## APPLICATION FOR PERMISSION UNDER SECTION 16 OF THE TOWN PLANNING ORDINANCE (CAP.131)

(d)	Name and number of the related statutory plan(s) 有關法定圖則的名稱及縝號 Approved Pat Heung Outline Zoning Plan No. S/YL-PH/11						
(e)	Land use zone(s) involved 涉及的土地用途地帶	"Open Storage" zone

PROPOSED TEMPORARY SHOP AND SERVICES WITH ANCILLARY STORAGE AND OFFICE FOR A PERIOD OF 5 YEARS LOTS 861 SA (PART) AND 861 S.C (PART) IN D.D. 111 AND GOVERNMENT LAND, HA CCHE, PAT HEUNG, YUEN LONG 11.10.2021 Drawing Title SWEPT PATH ANALYSIS scale of M 1:500 , M APPLICATION SITE

(S.16 Planning Application No. A/YL-PH/900)

PSIS PROPOSAL (1/4)

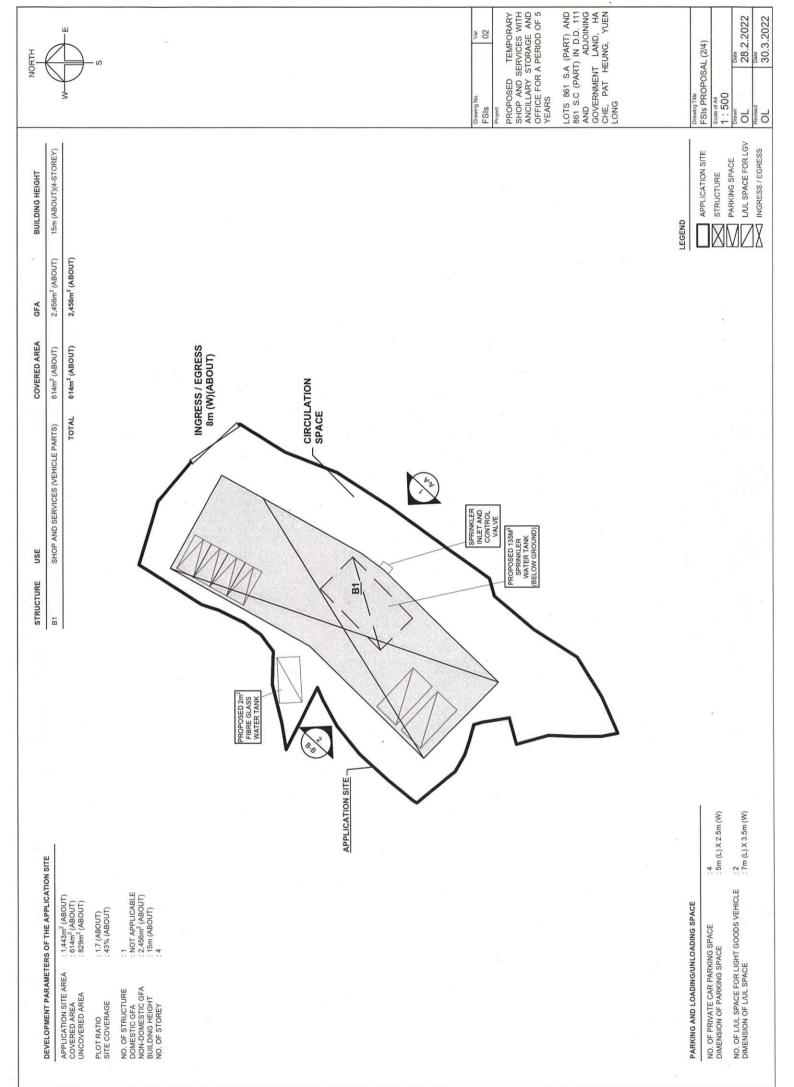
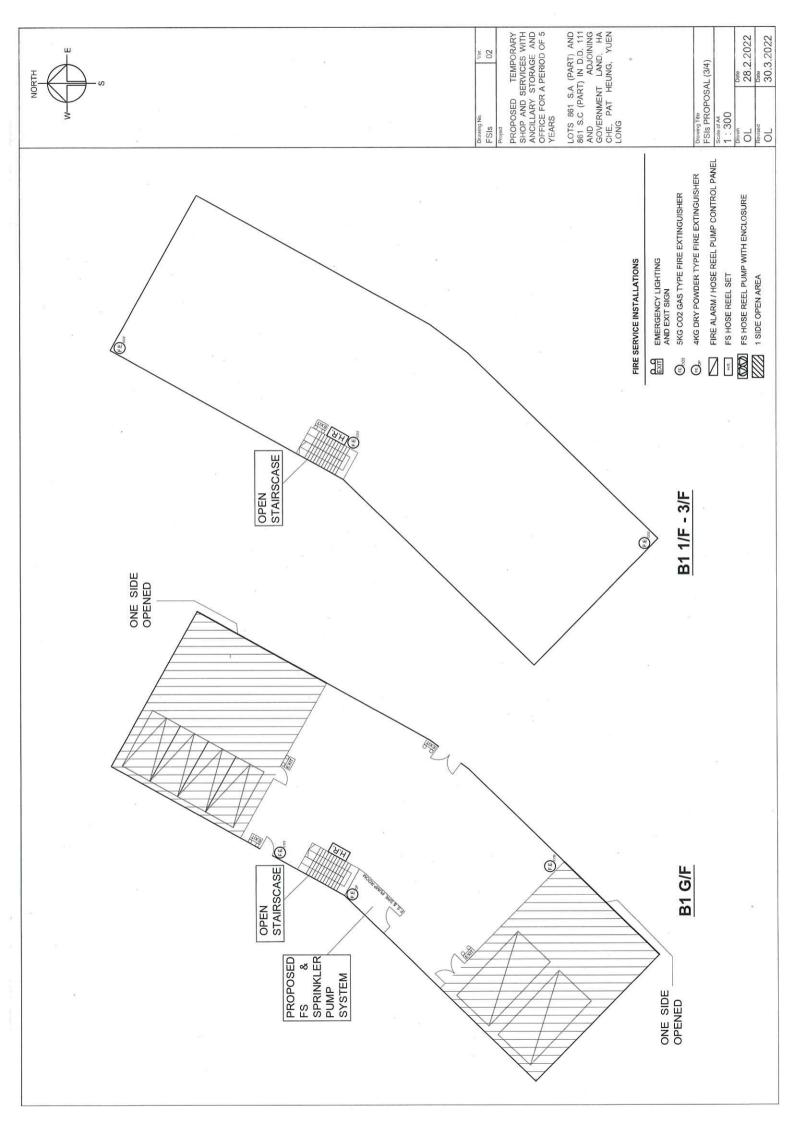
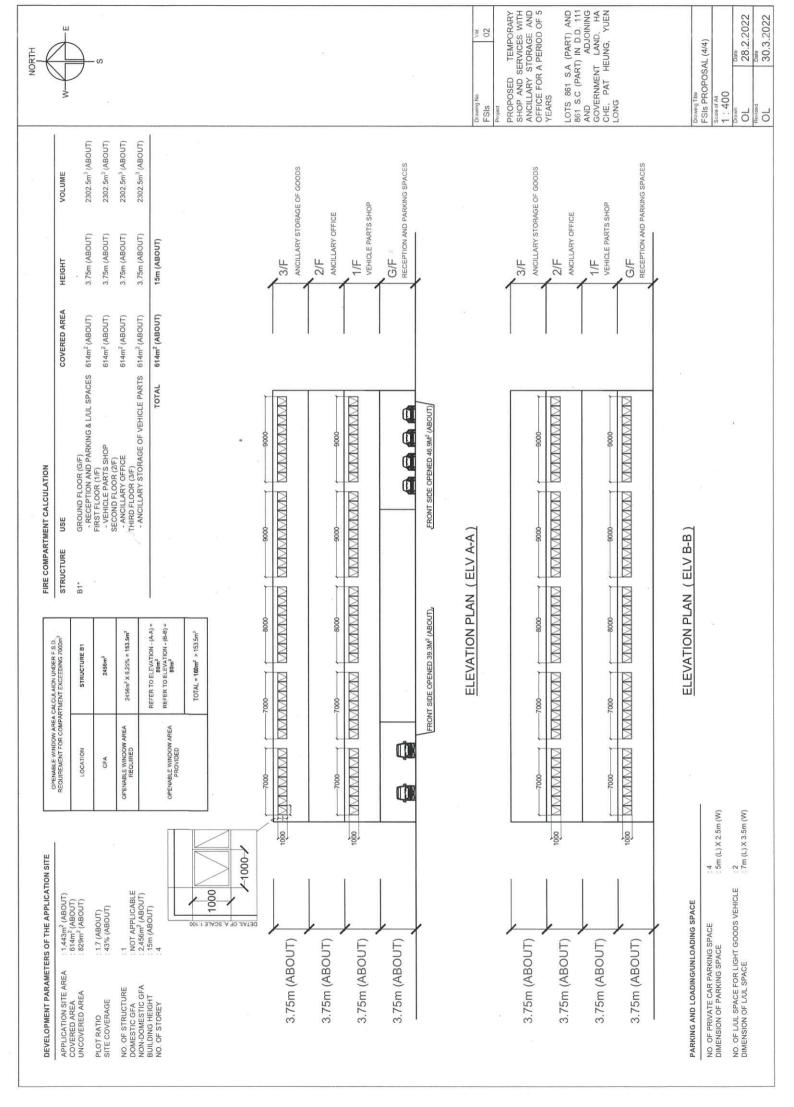
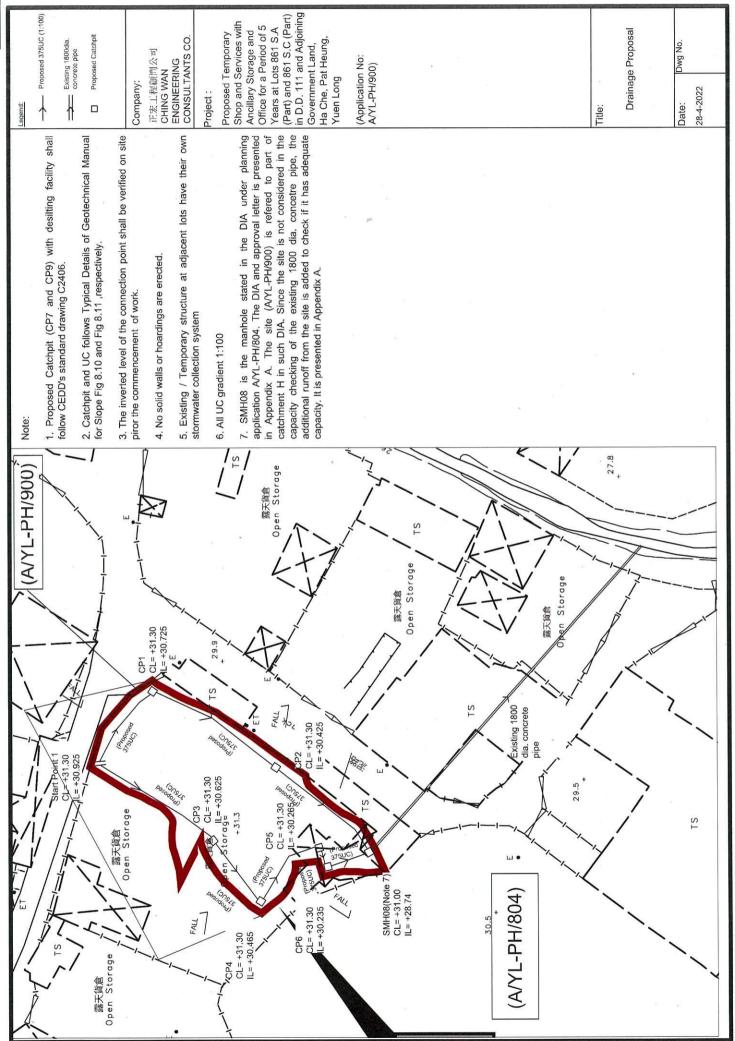
(b)	Please clarify if the proposed headroom of 3.75 m for LGV is the clear headroom.	The clear headroom of ground floor of structure B1 is 3.6m (about).
	   Comments of Chief Engineer/Mainland North   Contact Person: Mr. Thomson SZE; Tel: 2300	n, Drainage Services Department (CE/MN, DSD)

(a)	Please provide hydraulic design of the proposed underground pipe from CP7 to ultimate discharge point to demonstrate that the capacity of the proposed pipe is adequate.	Final discharge point has been reviewed and revised. The accepted drainage proposal approved under the approved S.16 planning application No. A/YL-PH/804 is referred to (Appendix A of Annex III).

(b)	The proposed uPVC underground pipe from CP7 to the ultimate discharge point has a shallow cover. Please provide structural design demonstrating the pipe can withstand the loading imposed on it. Provision of U-channel instead of

(d)	Grating covers shall be provided for all proposed catchpits.	Noted.
(e)	Please confirm that the proposed drains between CP7 to the ultimate discharge point would be maintained by the applicant.	Since final discharge point is revised, the Applicant will settle this issue with the applicant of the adjacent approved S.16 planning application No. A/YL-PH/804.

- HOSE REEL SHALL BE PROVIDED AT POSITIONS AS INDICATED ON PLANS.
- TUBING, ONE ACTUATING POINT AND ONE AUDIO WARNING DEVICE TO BE LOCATED AT EACH HR POINT. THE ACTUATING POINT SHOULD INCLUDE FACILITIES FOR THE FIRE THERE SHALL BE SUFFICIENT HOSE REELS TO ENSURE THAT EVERY PART OF THE BUILDING CAN BE REACHED BY A LENGTH OF NOT MORE THAN 30M OF HOSE REEL 1.7

- A MODIFIED HOSE REEL SYSTEM OF 2,000 LITRES WATER TANK TO BE PROVIDED FOR THE ENTIRE BUILDING AS INDICATED ON PLAN. PUMP START DEVICE INITIATION.
    - NO FIRE SERVICES INLET TO BE PROVIDED FOR THE MODIFIED HOSE REEL SYSTEM.

- WATER SUPPLY FOR THE MODIFIED HOSE REEL SYSTEM TO BE SINGLE END FEED FROM THE GOVERNMENT TOWN MAIN.
  - TWO FIXED FIRE PUMPS (DUTY/STANDBY) TO BE PROVIDED AT F.S. & SPR. PUMP ROOM.

- AUTOMATIC SPRINKLER SYSTEM SUPPLIED BY A 135,000L SPRINKLER WATER TANK AND HAZARD CLASS OH3 SHALL BE PROVIDED TO THE ENTIRE BUILDING/ STRUCTURE IN ACCORDANCE WITH LPC RULES INCORPORATING BS EN12845: 2003 AND FSD CIRCULAR LETTER 3/2006 & 3/2012. THE SPRINKLER TANK, SPRINKLER PUMP ROOM, SPRINKLER INLET AND SPRINKLER CONTROL VALVE GROUP SHALL BE CLEARLY MARKED ON PLANS. 2.1
  - THE CLASSIFICATION OF THE AUTOMATIC SPRINKLER INSTALLATION TO BE ORDINARY HAZARD GROUP 3. 2.2 2.3 2.4 2.5
    - ONE NUMBER 135,000 LITRES SPRINKLER WATER TANK TO BE PROVIDED AS INDICATED ON PLANS.
      - SPRINKLER CONTROL VALVE SET AND SPRINKLER INLET TO BE PROVIDED AS INDICATED ON PLANS.
        - TYPE OF STORAGE METHOD FOR THE BUILDING IS AS FOLLOWS:
          - STORAGE CATEGORY: CATEGORY (I)
